## National Committee on Uniform Traffic Control Devices

**Bicycle No. 3**

### TECHNICAL COMMITTEE RECOMMENDATION

**TOPIC:** Proposed Shared Lane Marking  
Part 9 of the MUTCD

Diagram from San Francisco Shared Lane Marking study

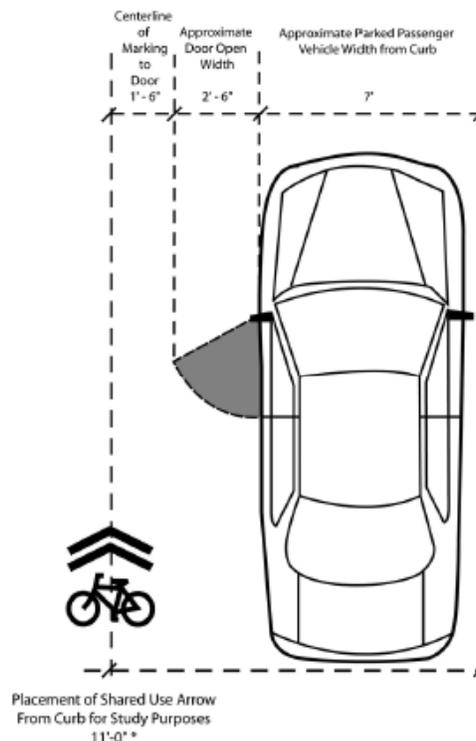
The draft proposal that the Bicycle Technical Committee is transmitting to sponsors is based on the findings of the San Francisco study and the language and figure adopted in the MUTCD California Supplement.

Results from the San Francisco study indicate that the shared lane marking:

- Improves positioning of the bicyclist and motorist
  - Increases the distance between bicyclists and parked cars (by 8 inches in the SF study)
  - Increases the distance between overtaking motorists and bicyclists (by 2 feet in the SF study)
- Improves bicyclist behavior
  - Reduces wrong-way bicycling, a major cause of collisions (by 80% in the SF study)
- Reminds motorists of likely bicyclist presence
  - When surveyed, motorists claimed they did not notice the marking; however, the data indicates that their position on the roadway was adjusted to better accommodate bicyclists.

The Shared Lane Marking shown in Figure 9C-X may be used to assist bicyclists with positioning in a shared lane with on-street parallel parking and to alert road users to the location a bicyclist may occupy within the traveled way.

**If used in a shared lane with on-street parallel parking, Shared Lane Markings shall be placed so that the centers of the markings are a minimum of 3.3 m (11 ft) from the curb face, or from the edge of pavement where there is no curb.**

When used, the Shared Lane Marking should be placed immediately after an intersection and spaced at intervals not greater than 75 m (250 ft) thereafter.
